ELGEMS

The letter bellow (12 pages) provides the required information you asked in your E-mail of 12/10/99. The answers are in bold letters just after your question.

MG AC Project

Radiation Leakage from the Transmission Source Lead Shipping Container.

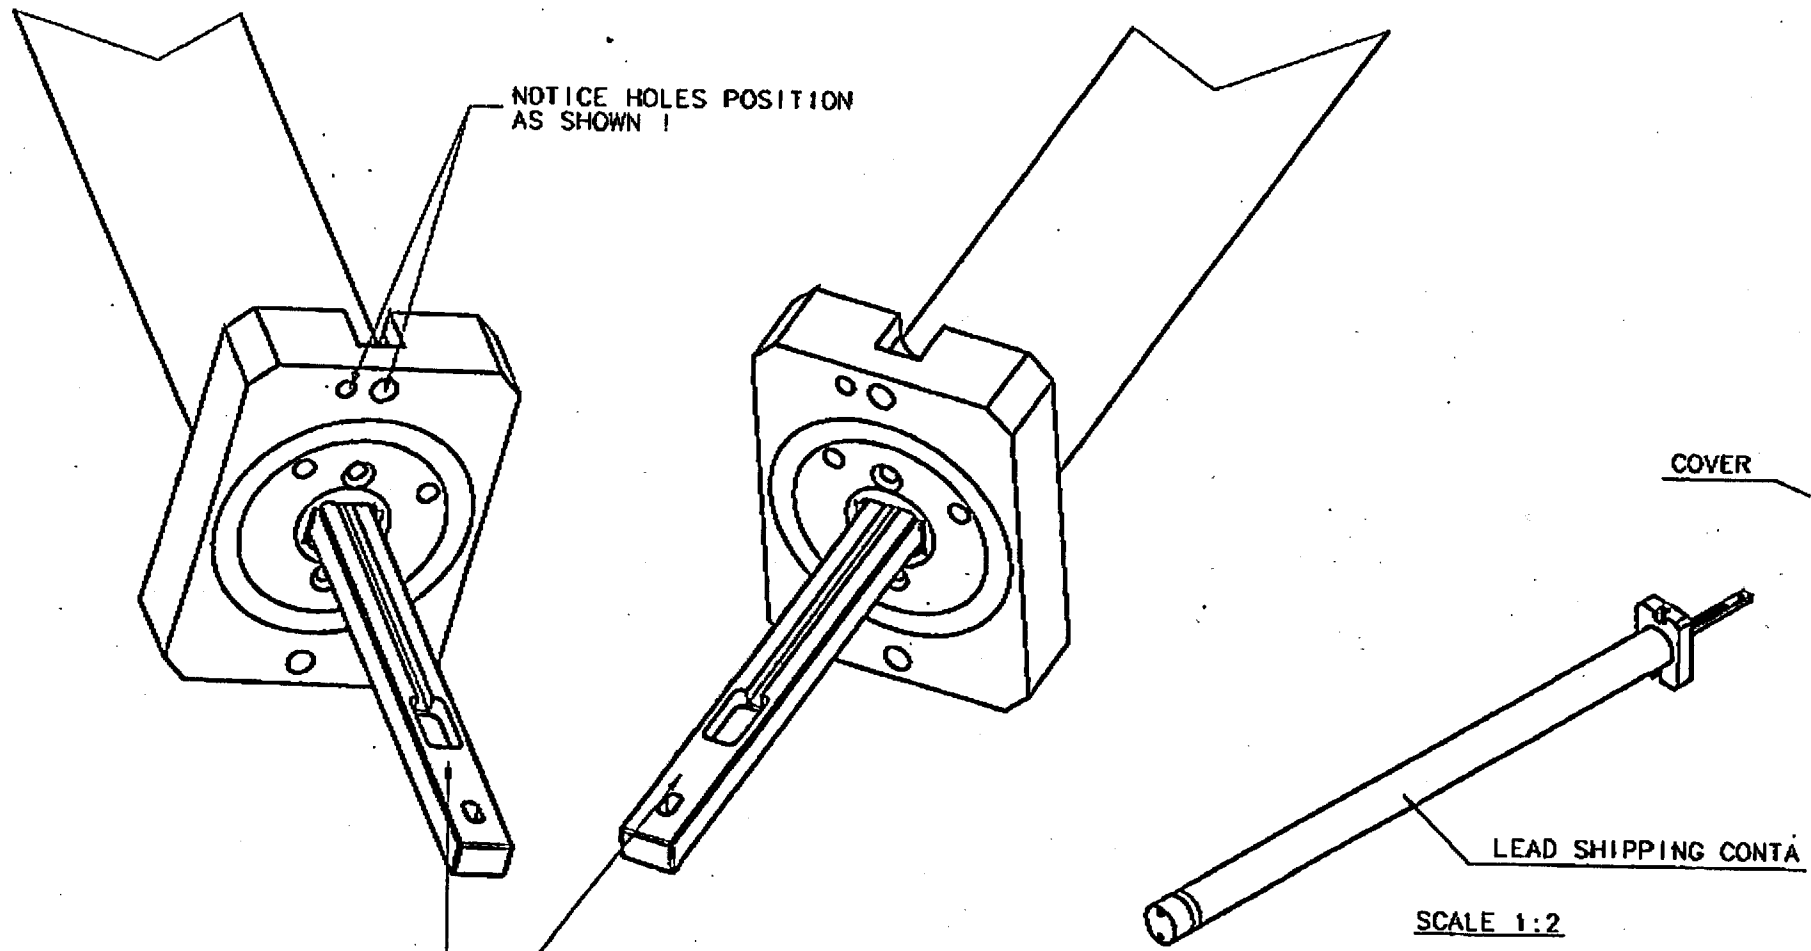
4. How is the thin source supported inside the lead shipping container? Provide the details for the supporting mechanism.

The thin source is glued to a groove on a source holder (page 3 on the original submission file - "Description of the shielding and method for securing the source in device").

Test	Expected Result	Pass/Fail
Visually check the assembled part for any external damage	No external damage	
Check if any internal parts are loose and if any screws are not fully tightened.	No internal parts loose. Screws fully tightened.	
Disassembled the cover from the container and manually insert the source holder p/n 119040005 all the way in (see drawing MEC-005512).	Insertion/removing should be smooth with no internal obstacles or friction.
